MARES TECHNICAL ASSISTANCE OFFICE HAS THE PLEASURE TO INFORM HIS MARES LAB CENTERS ABOUT THE 2ND STANGE COVER ABYSS UPGRADE.. THE RELEVANT CODES OF MODIFIED SPARE PARTS ARE: 46200849-46200850-46200851. THE IMPROVEMENT CONCERNS THE FIXING OF THE METAL FOIL (MESH GRID) TO THE COVER. THIS NEW SOLUTION PREVENTS THE FRONT COVER DETACHMENT CAUSED BY A STRONG IMPACT ESPECIALLY ON THE SURFACE.

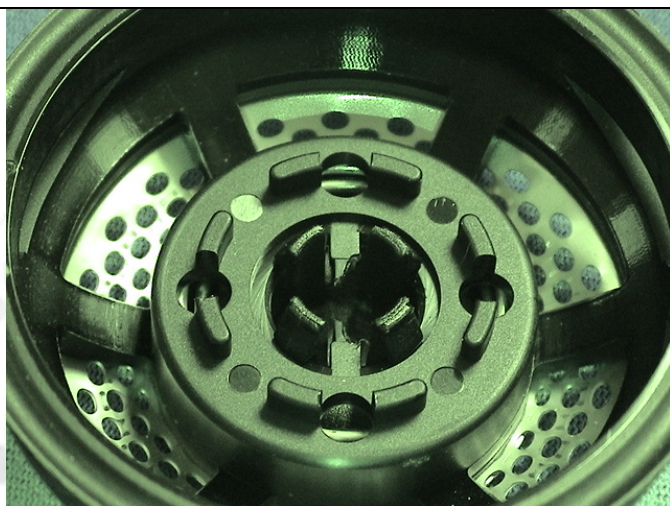
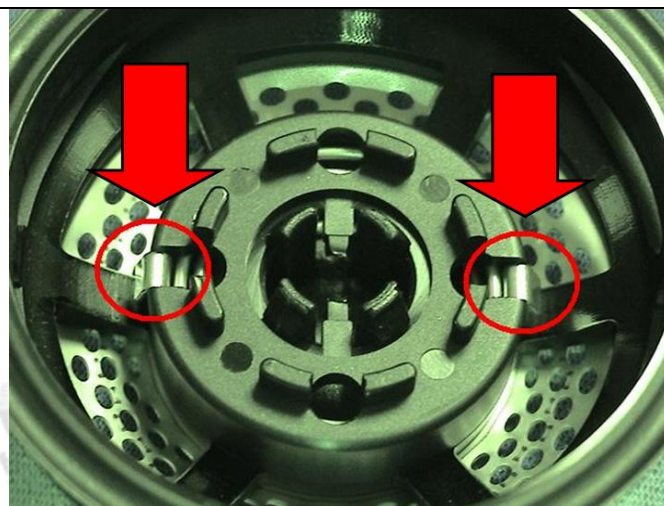
THE NEW COVERS CAN BE IDENTIFIED BY TWO INNER HOOKS AS PER THE PHOTO PAGE 2.
